# Architectural Review Board

## Staff Report (ID # 9390)

**Summary Title:** 3223 Hanover Street: New Office/R&D Building (2nd Formal)

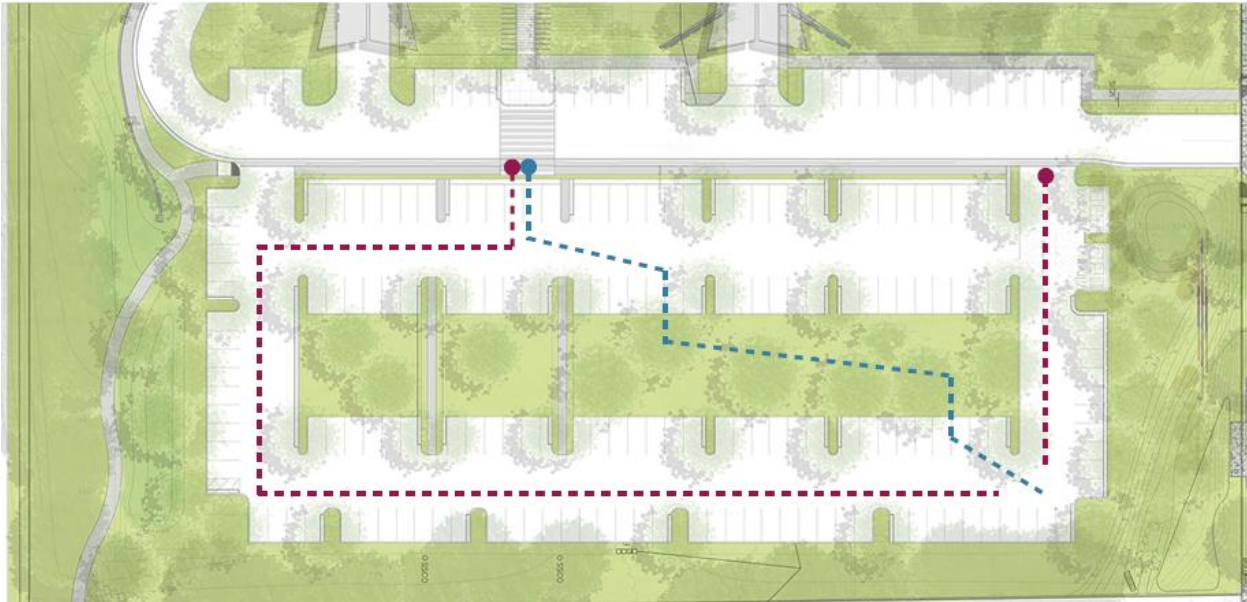
The largest substantive change between the current plans and those provided at the March 15, 2018 hearing is the replacement of one of the parking modules with a new landscaped area with seating, shade trees, and other landscaping. This feature would serve as a terminus to the staircase leading from the lower platform to the upper platform. This feature also reduces the number of parking spaces in the lower lot by 26 spaces, which brings the number of parking spaces planned for the initial buildout to the minimum number required for the site. However, the proposed plans still include 20 additional parking spaces above the minimum in a landscape reserve along the southern edge of the main drive aisle, all of which could be converted to parking at any time after project approval with minimal discretionary review. It is also unclear what these areas would be covered with at the onset, as the updated L\_1.0 sheet in the project plans indicates a surface type "PA" which is not included in the materials schedule (for reference, pavement surfaces have been noted "PV-#"), while Sheet L\_2.0 indicates that the landscape reserve areas will be planted with Coyote Brush. Staff believes that the number of parking spaces, inclusive of those shown as landscape reserve areas, should be reduced to the minimum required in order to provide latitude for alternative surface parking arrangements and to reduce the amount of asphalt to the degree necessary. The code-prescribed use of the 'landscape reserve' provision cited in PAMC 18.52.050(b) is associated with 'deferral of meeting full requirement' of parking spaces for the use, and not for a potential future parking expansion area that would result in an over-parked project.

The applicant showed an alternative surface parking lot arrangement to the Board at the March 15, 2018 hearing (image below), and indicated that such an arrangement, which contained only two intersecting drive aisles and a rotation of the parking modules, resulted in a site plan that was 10 parking spaces short of the minimum required. Staff is supportive of the alternative arrangement in concept and believes that an alternative site arrangement merits additional study by the applicant. To the question of parking noncompliance, staff believes that, on a 10 acre site, the 10 missing parking spaces could be located in a number of possible locations, including in a slightly modified parking garage or on either interior side of the central median shown in the alternative arrangement. If no alternative location for the 10 spots is viable, it is worth noting that the project includes a TDM plan to reduce peak hour trips by 30% over standard rates, and that a parking adjustment of 10 spaces (constituting 1.7% of the total number of spaces) could potentially be considered. Staff believes that the alternative arrangement also more sufficiently responds to the Board's comments regarding enhanced landscaping in the parking lot, and could provide heat island, aesthetic, and habitat improvements.

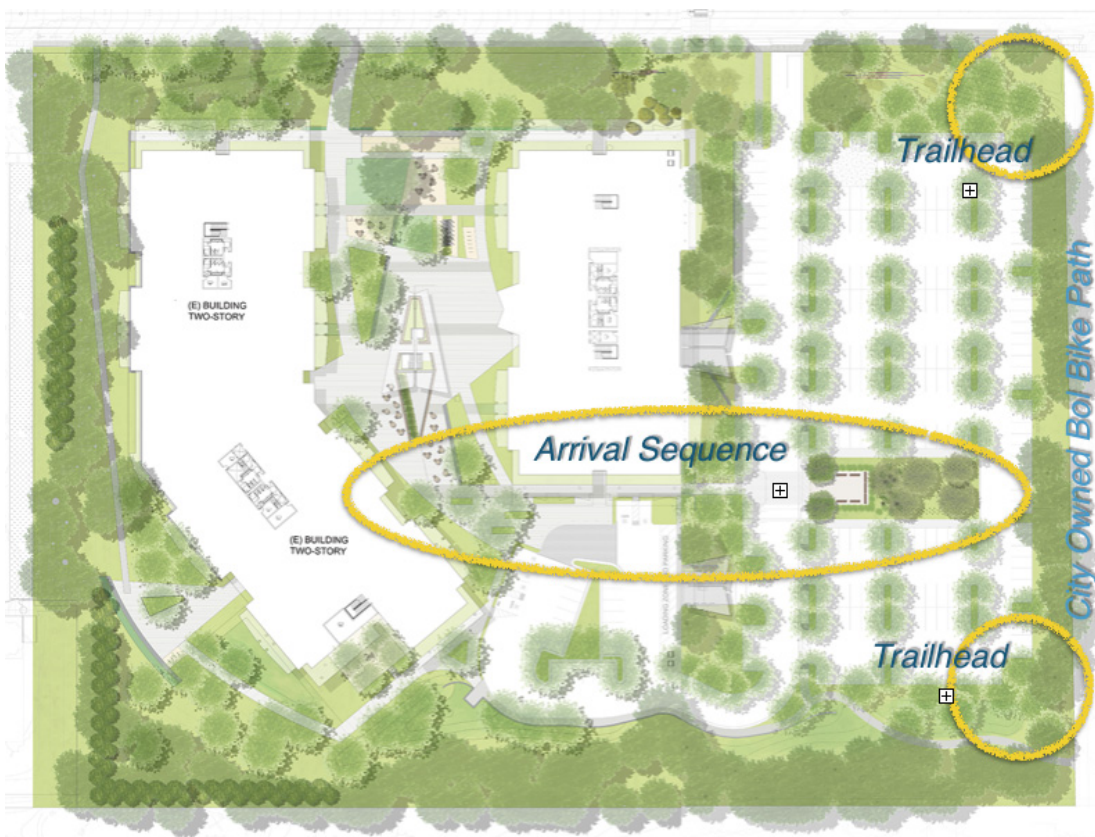
Based on discussions at our March 15, 2018 initial hearing we revised the lower parking to include a mini park, diagrammed in the graphic below. Two rows of cars and the driveway between were replaced by landscaping. This “compartmentalized” the surface parking into two areas. More importantly it creates a small plaza with benches just before one crosses the drive and walks up the grand stair to the courtyard.
